UNITED STATES PATENT AND TRADEMARK OFFICE

APPLICATION NO.	FILING DATE	FIRST NAMED INVENTOR	ATTORNEY DOCKET NO.	CONFIRMATION NO.
10/628,860	07/28/2003	Joseph S. Bieganeck	249.303	3850

Office Action Summary	Application No.		Applicant(s)	
	10/628,860		BIEGANEK ET AL.	
	Examiner		Art Unit	
	M. Safavi		3673

Continuation of Attachment(s) 6). Other: Attached Sheets 1 & 2, (pages 37 & 38), showing respective drawing figures from each of Matsler et al. '352, Johnson '649, Landi et al. '595, and Lonardo '492.

Attached Sheet 1:

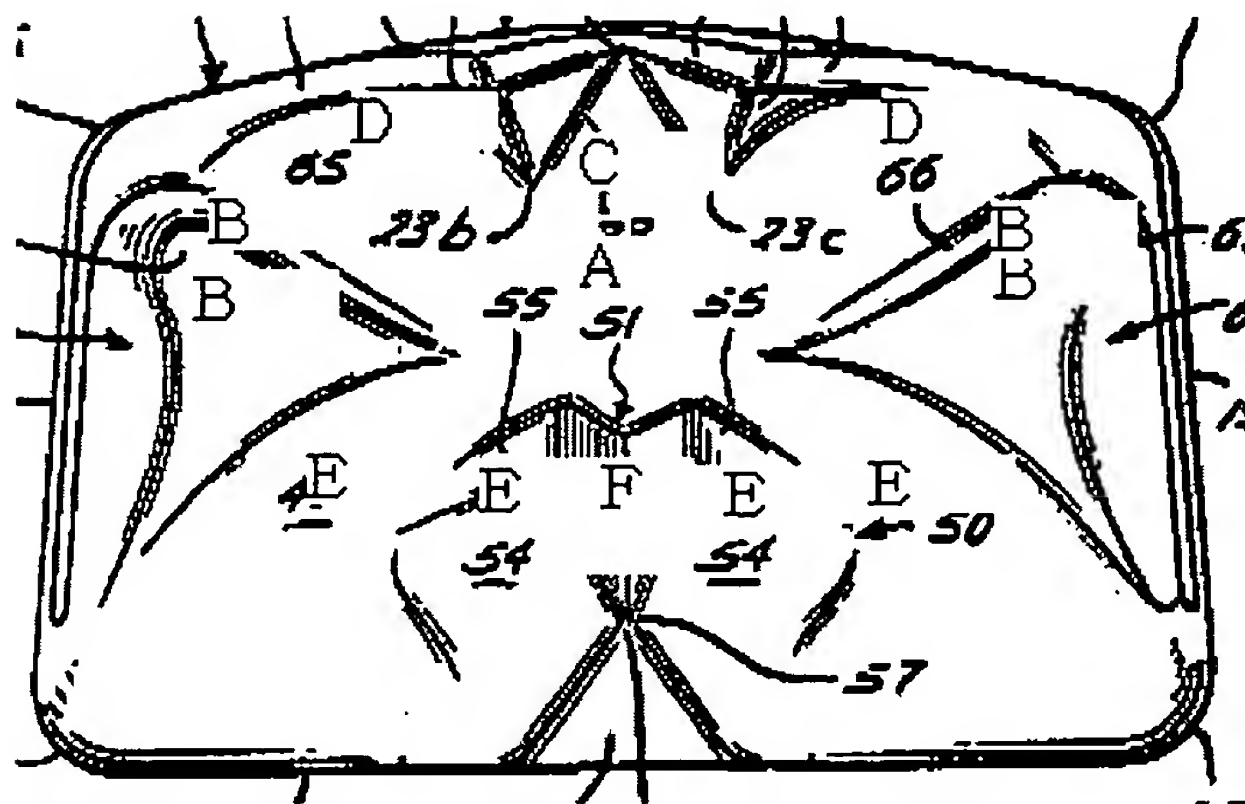
As for **claim 53**, Matsler et al. discloses, Fig. 1, (see also attached sheet 1), a cushion extending longitudinally from a rear wall to a front edge, the cushion also extending transversely between opposite transverse edges, each transverse edge extending longitudinally between the rear wall and the front edge; a cavity (designated as 'A' on the attached Figure), located adjacent to the rear wall and spaced rearward from the front edge along the longitudinal midline, the cavity located between and spaced transversely inward from the opposite transverse edges, the cavity extending downward to a lower surface; two transverse relief areas, *(just inside of 20a of edge 20 on either side; designated as 'B' on the attached Figure)*, each transverse relief area spaced transversely to the outside of the cavity and transversely to the inside of the opposite transverse edges, each transverse relief area spaced vertically above the lower surface of the cavity; a channel, *(59 shown along 28; designated as 'C' on the attached Figure)*, in the back wall at a location approximately centered transversely about the longitudinal midline, the channel extending generally vertically upward from the lower surface of the cavity, the channel recessed rearward into the back wall relative to the midline contour of the back wall; two rear support areas, *(22 on either side;*

As for **claim 59**, Matsler et al. shows a clearance area, *(that portion extending upwardly and forwardly from the lower surface of the cavity and approximately centered about the longitudinal midline; also including central 59; designated as 'F' on the attached Figure).*

As for **claim 53**, Johnson discloses, Figs. 1 and 2, (see also attached sheet 1), a cushion extending longitudinally from a rear wall to a front edge, the cushion also extending transversely between opposite transverse edges, each transverse edge extending longitudinally between the rear wall and the front edge; a cavity (designated as 'A' on the attached Figure), located adjacent to the rear wall and spaced rearward from the front edge along the longitudinal midline, the cavity located between and spaced transversely inward from the opposite transverse edges, the cavity extending downward to a lower surface; two transverse relief areas, *(just inside of edge 14, 15 on either side; designated as 'B' on the attached Figure [area of 62, 63 or area of 65, 66])*, each transverse relief area spaced transversely to the outside of the cavity and transversely to the inside of the opposite transverse edges, each transverse relief area spaced vertically above the lower surface of the cavity; a channel, *(within 23; designated as 'C' on the attached Figure)*, in the back wall at a location approximately centered transversely about the longitudinal midline, the channel extending generally vertically upward from the lower surface of the cavity, the channel recessed rearward into the back wall relative to the midline contour of the back wall; two rear support areas, *(on either side of the channel and just below 31, 32; designated as 'D' on the attached Figure)*, each rear support area located on the back wall on respectively opposite transverse sides of the longitudinal midline, each rear support area located

As for **claim 59**, Johnson shows a clearance area, (*that portion extending upwardly and forwardly from the lower surface of the cavity and approximately centered about the longitudinal midline such as of 51 or ascending portion of 55, 55; designated as 'F' on the attached Figure*).

Landi et al. 5,617,595

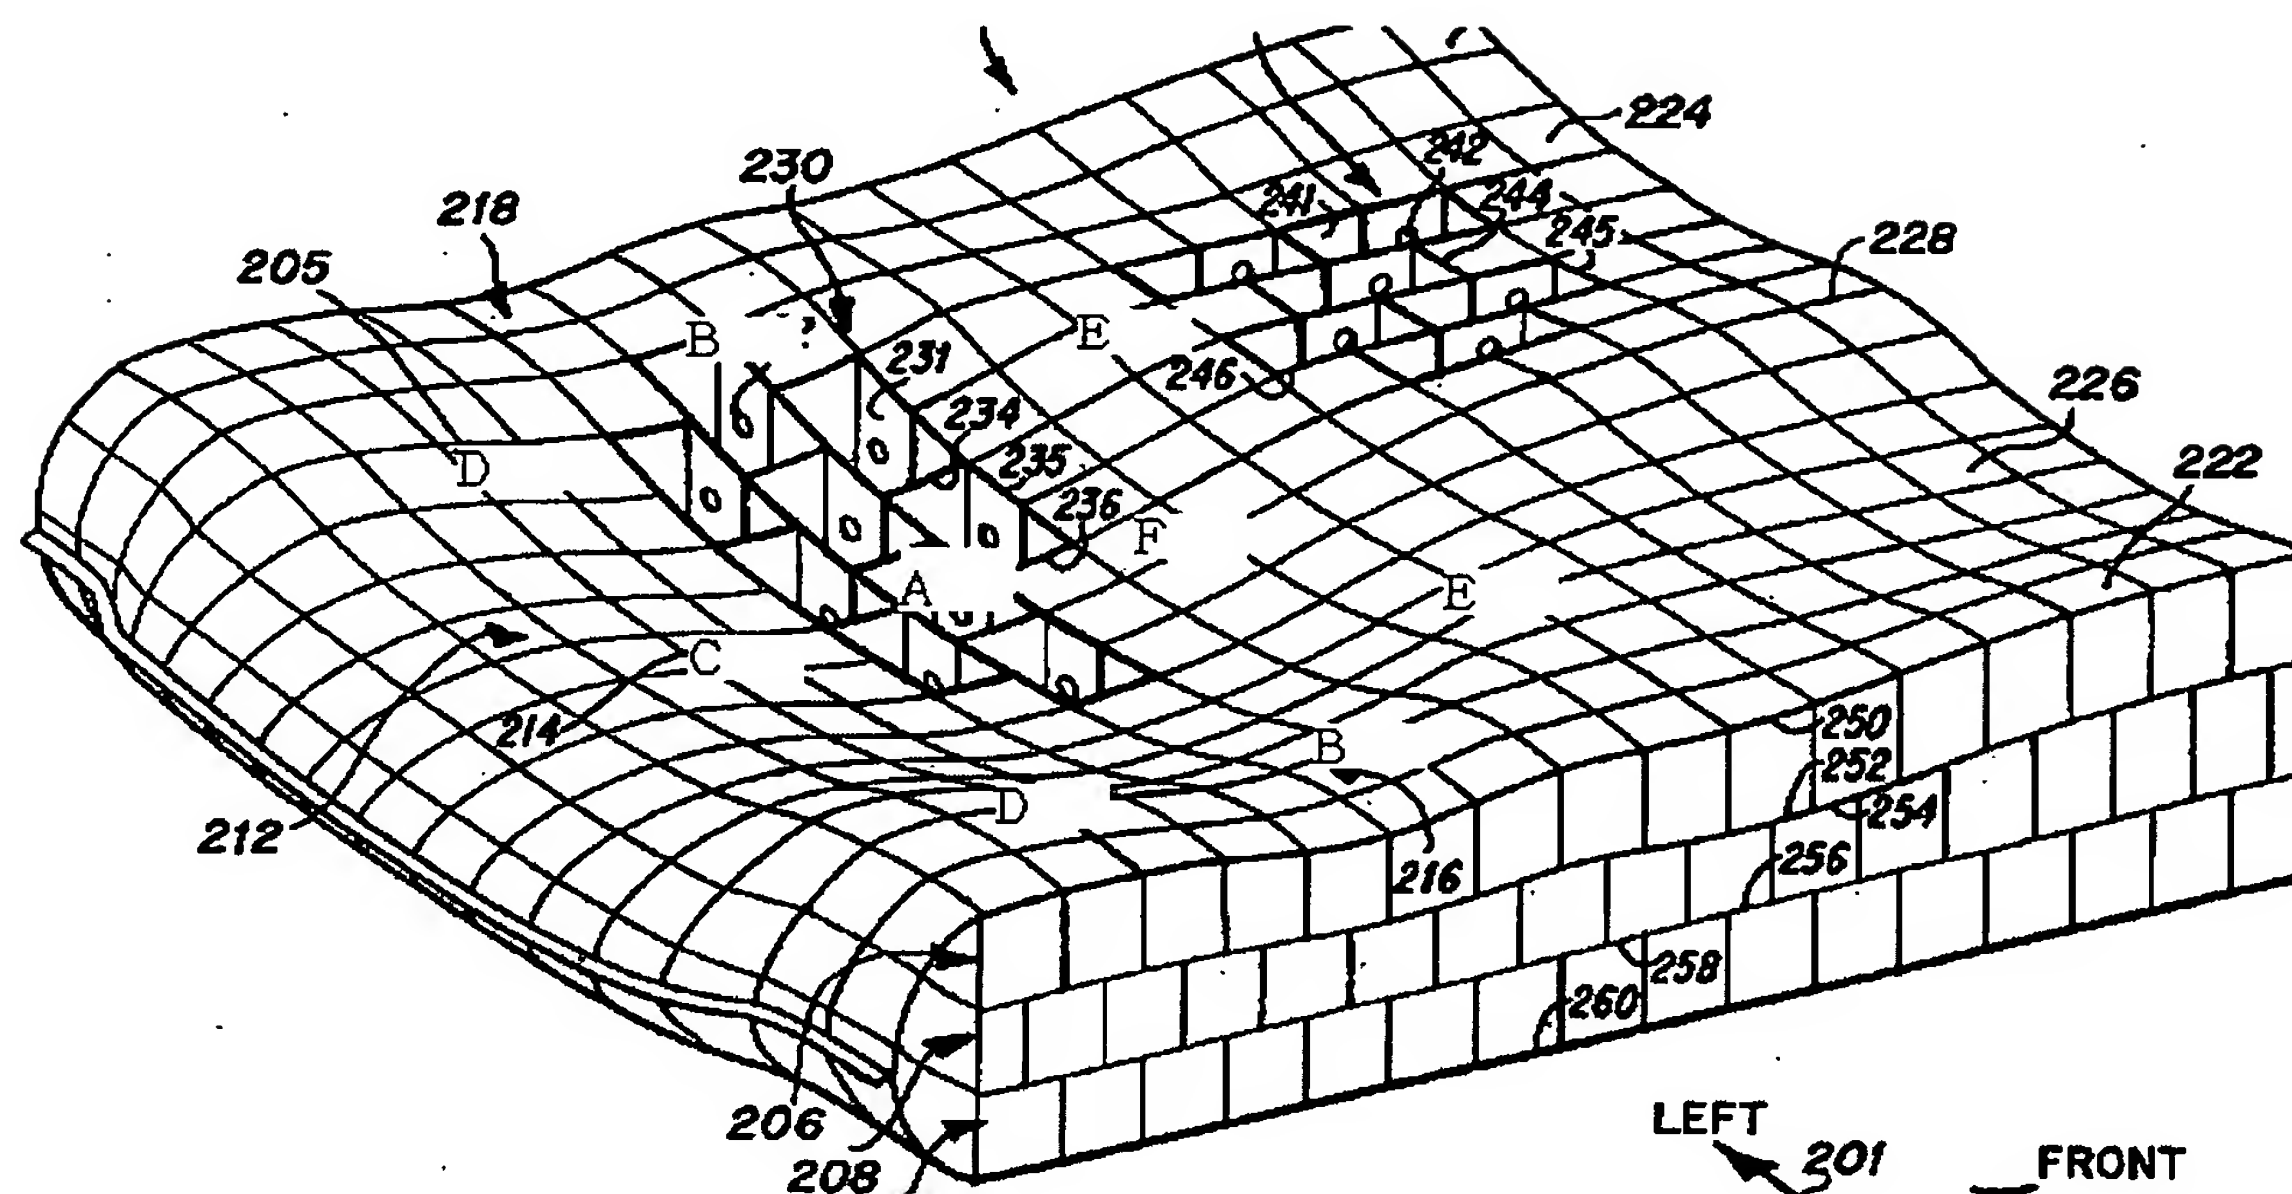
As for **claim 53**, Landi et al. discloses, Fig. 17, (see also attached sheet 2), a cushion extending longitudinally from a rear wall to a front edge, the cushion also extending transversely between opposite transverse edges, each transverse edge extending longitudinally between the rear wall and the front edge; a cavity (designated as 'A' on the attached Figure), located adjacent to the rear wall and spaced rearward from the front edge along the longitudinal midline, the cavity located between and

As for **claim 59**, Landi et al. shows a clearance area, *(that portion extending upwardly and forwardly from the lower surface of the cavity and approximately centered about the longitudinal midline; designated as 'F' on the attached Figure)*.

Lonardo '492

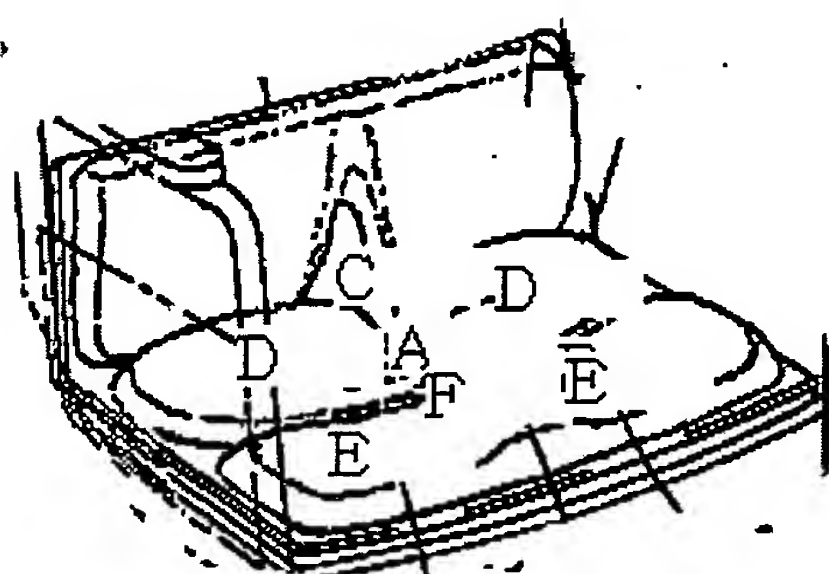
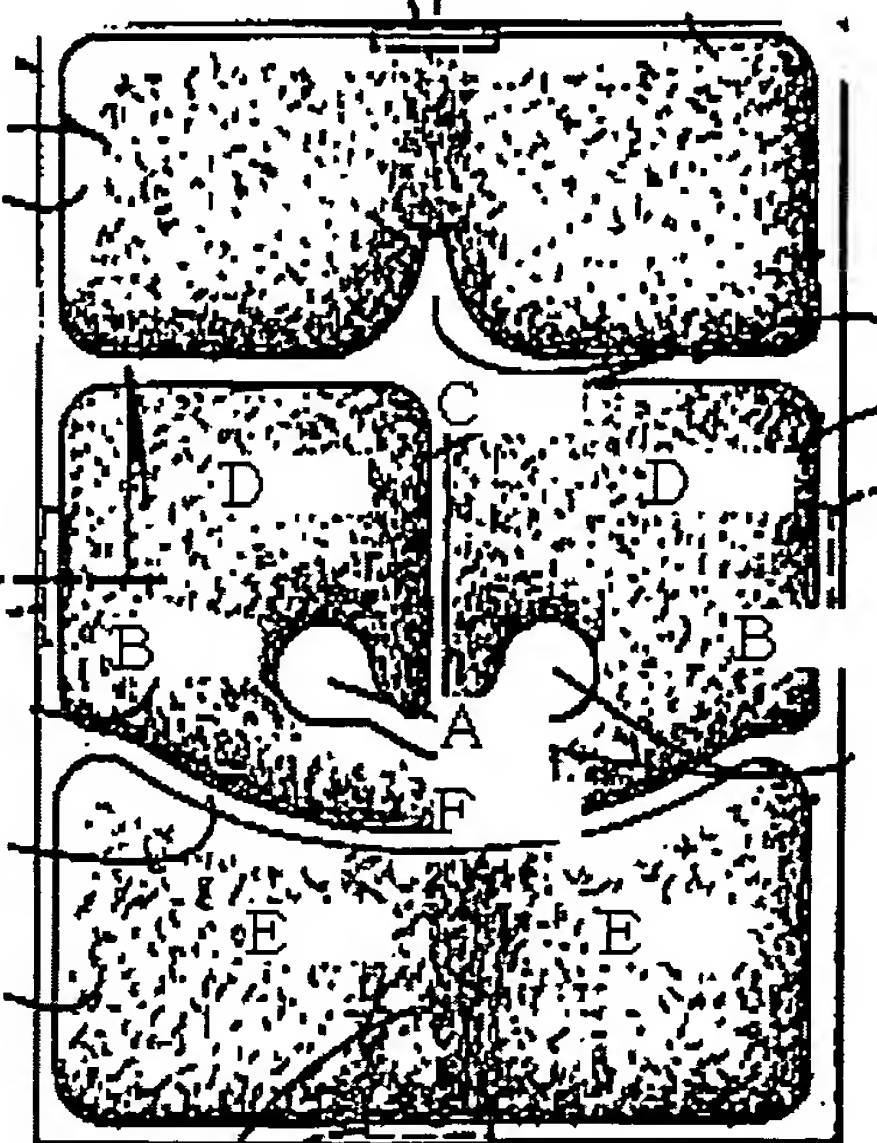
As for **claim 53**, Lonardo discloses, Figs. 1 and 2, (see also attached sheet 2), a cushion extending longitudinally from a rear wall to a front edge, the cushion also extending transversely between opposite transverse edges, each transverse edge extending longitudinally between the rear wall and the front edge; a cavity (designated as 'A' on the attached Figure), located adjacent to the rear wall and spaced rearward from the front edge along the longitudinal midline, the cavity located between and spaced transversely inward from the opposite transverse edges, the cavity extending downward to a lower surface; two transverse relief areas, *(just inside of each longitudinal edge on either side; designated as 'B' on the attached Figure)*, each

As for **claim 59**, Lonardo shows a clearance area, *(that portion extending upwardly and forwardly from the lower surface of the cavity and approximately centered about the longitudinal midline; designated as 'F' on the attached Figure)*.
